MODIFICATION INSTRUCTIONS

ENGINEERING CHANGE NOTICE

ECN # 978

EFFECTIVE DATE	ASSEMBLY	PART NUMBER	DRAWING NUMBER	REV
8-24-81	CPU BOARD	800-0107	800-0107	E

PRINTED CIRCUIT BOARD

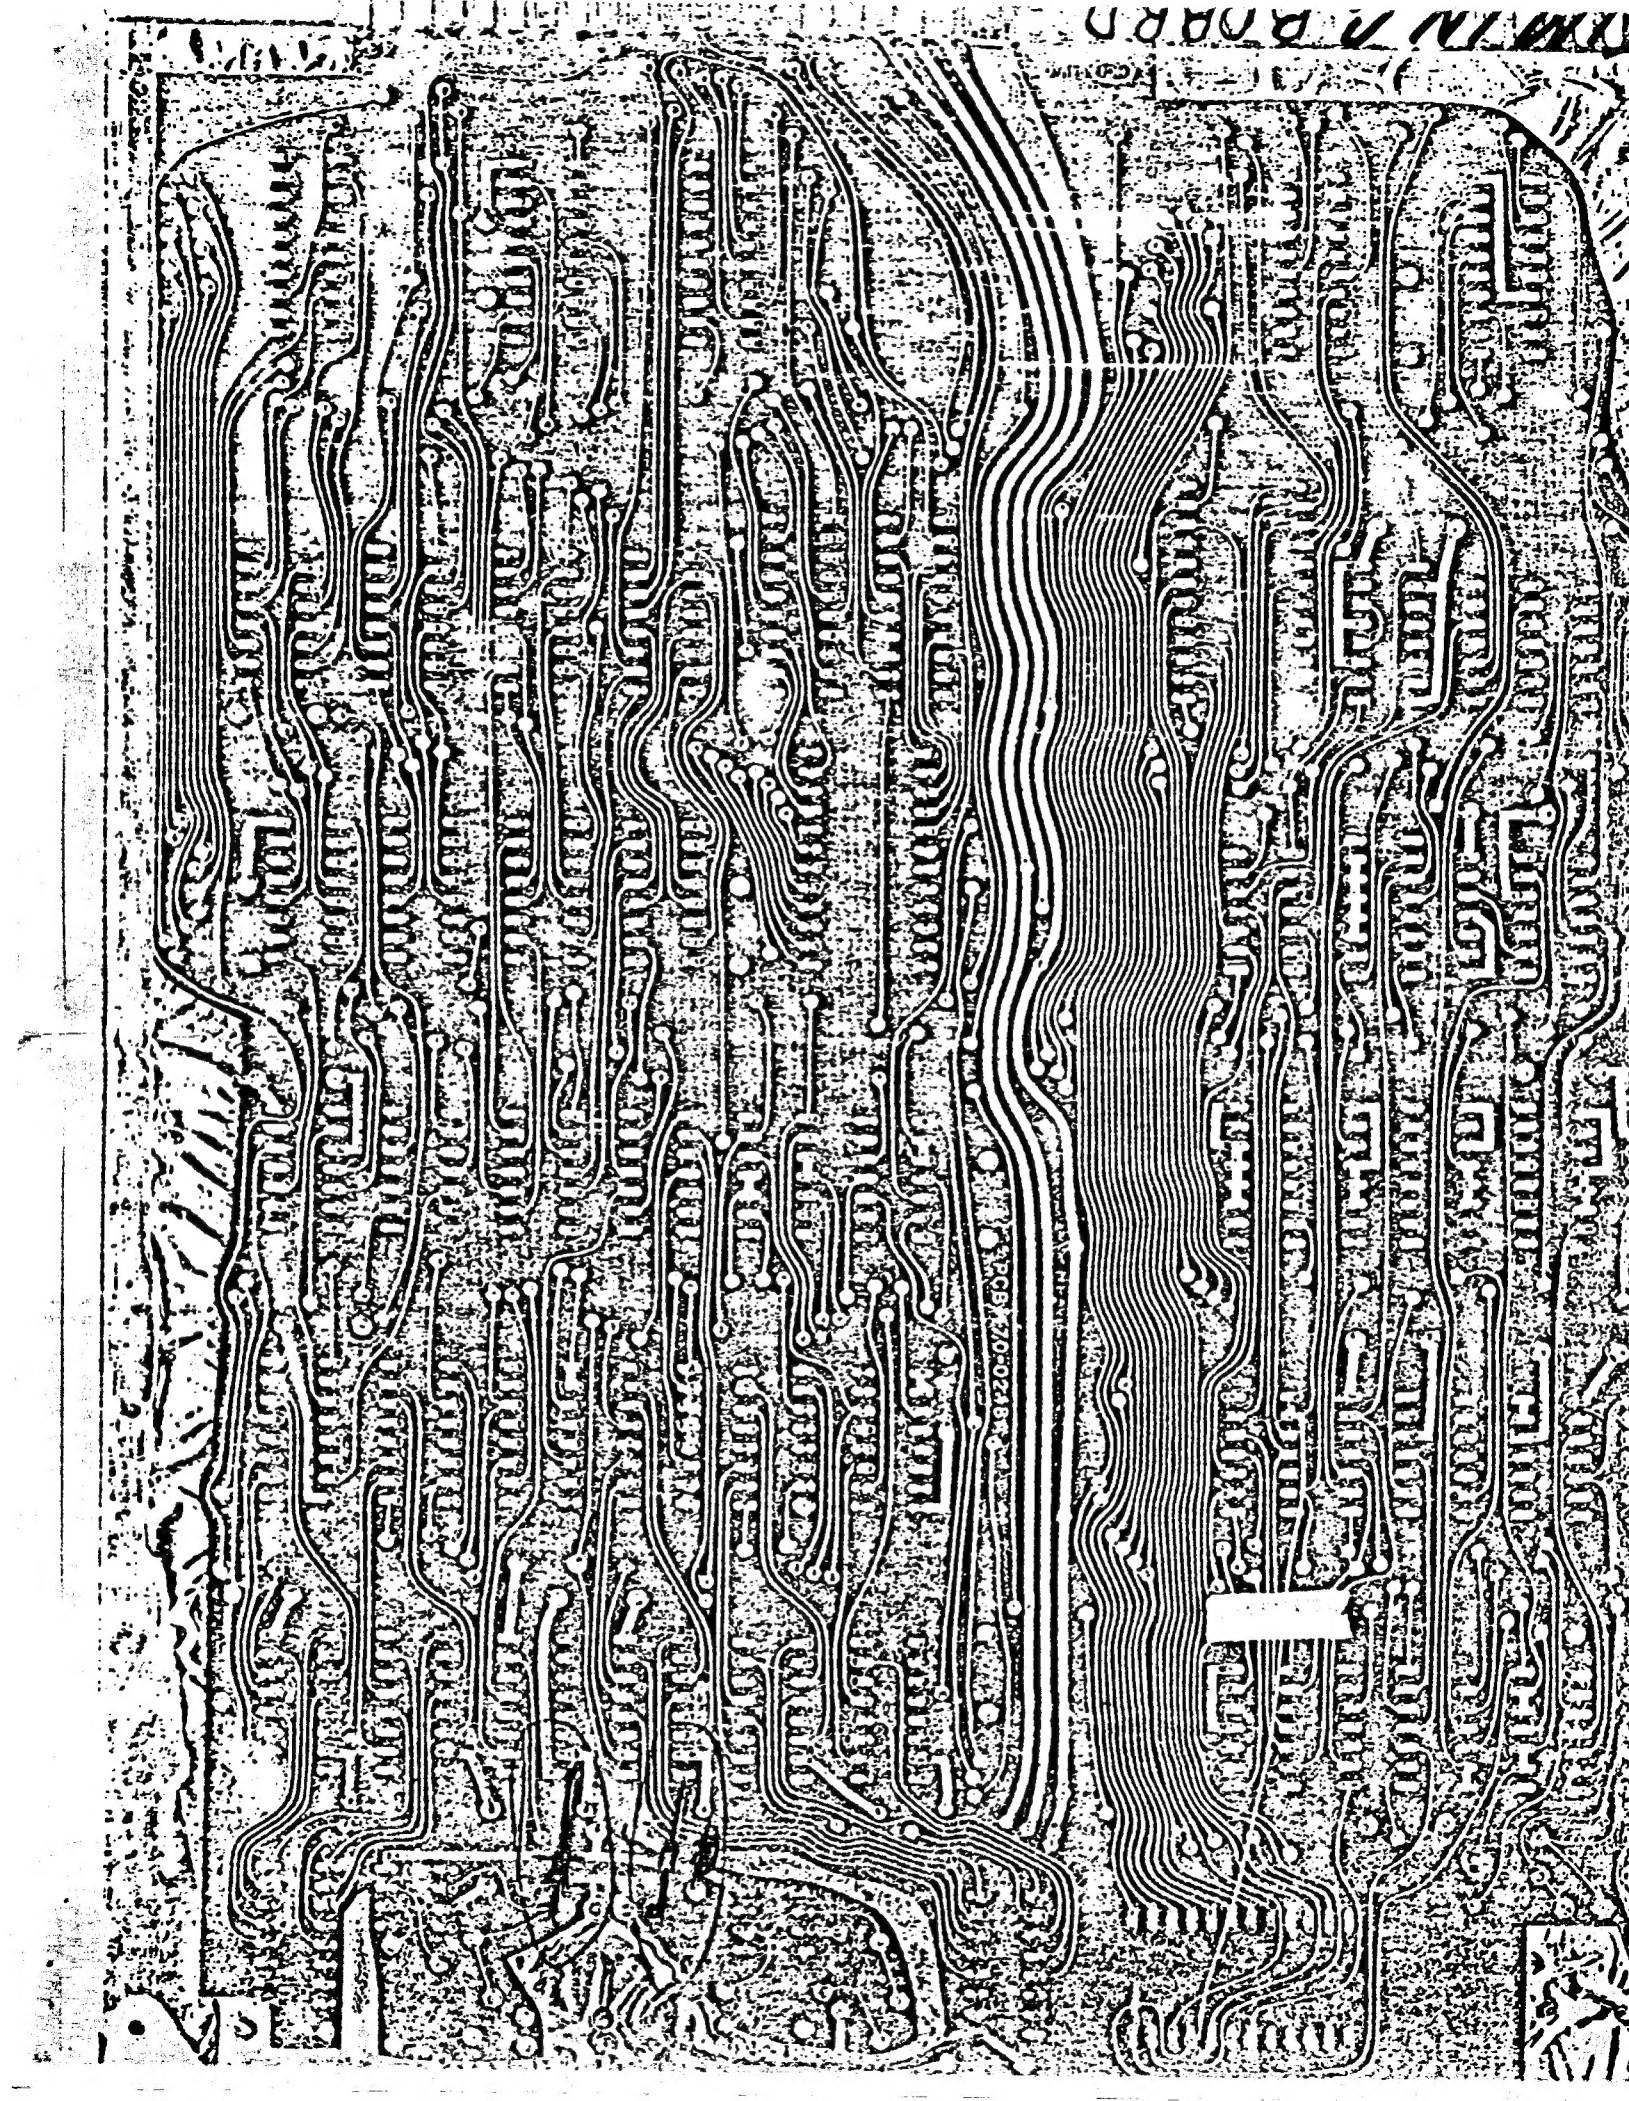
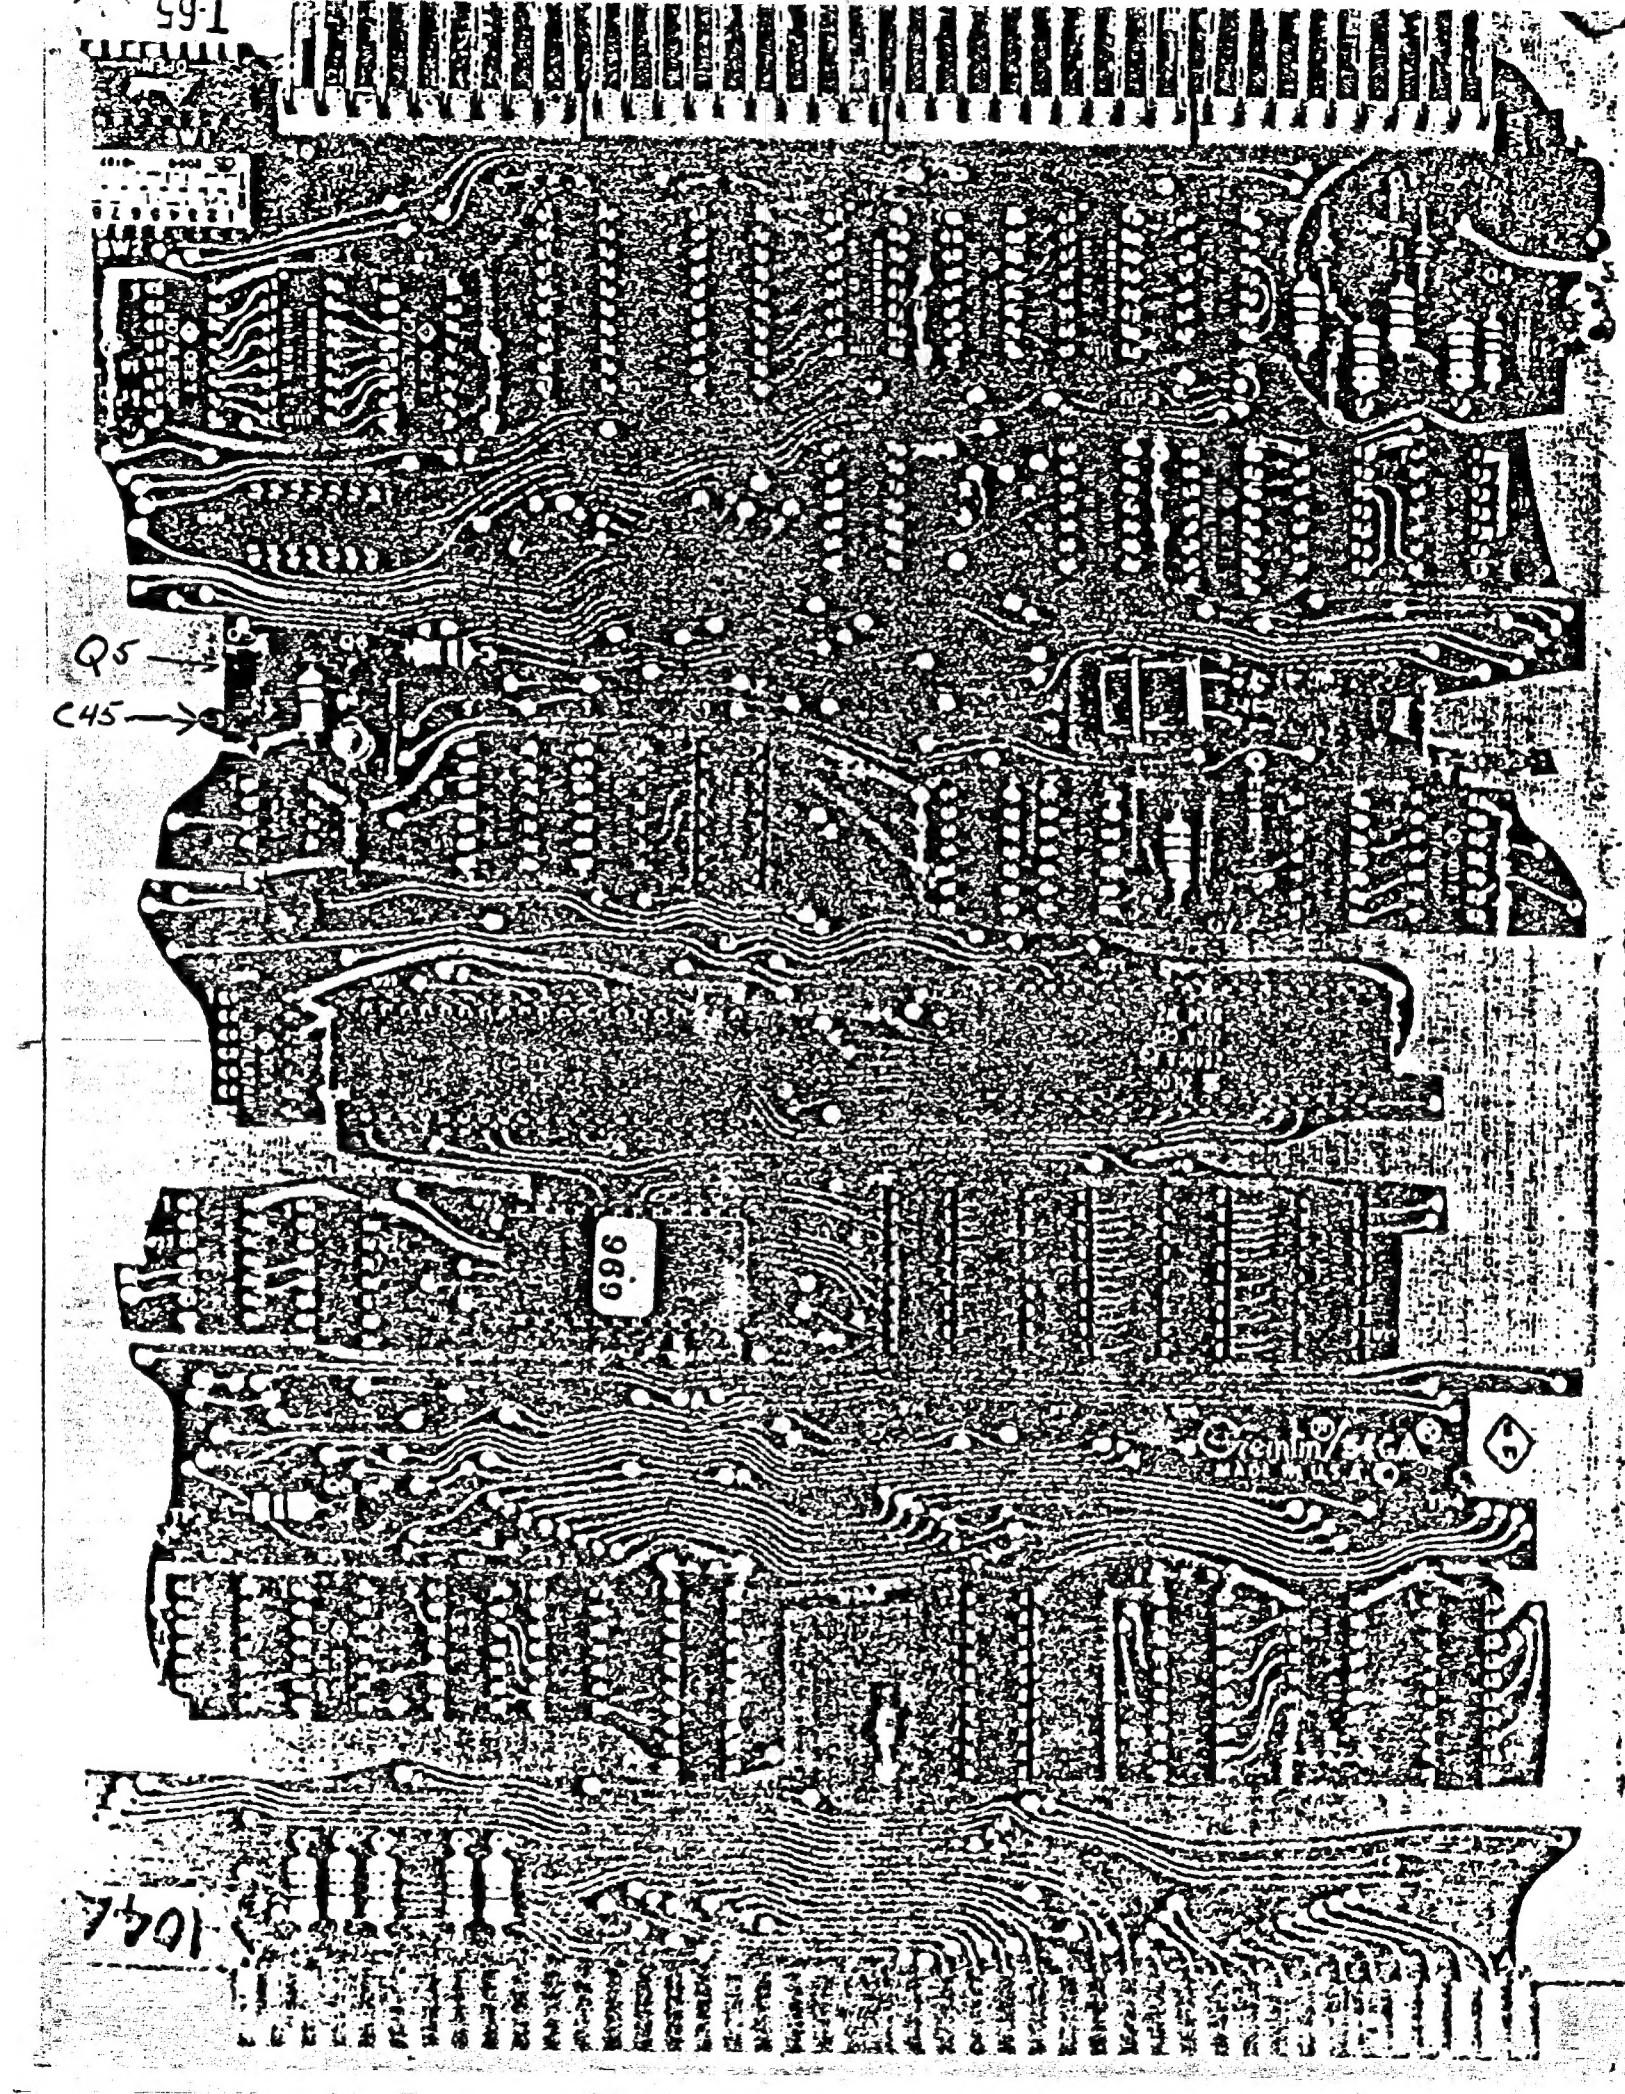
CHANGE SHEET 6 ZONE 7A:

IS:  C45
 .22 UF
 16V

WAS:  C45
 10 UF
 25 V

REDUCE POWER ON DELAY FROM 1.5 SECS TO 20 MSECS
 TO ALLOW XV MONITOR OUTPUTS TO BE RESET IN 20
 MSECS THEREBY REDUCING STRESS ON MONITOR
 OUTPUT CIRCUITS
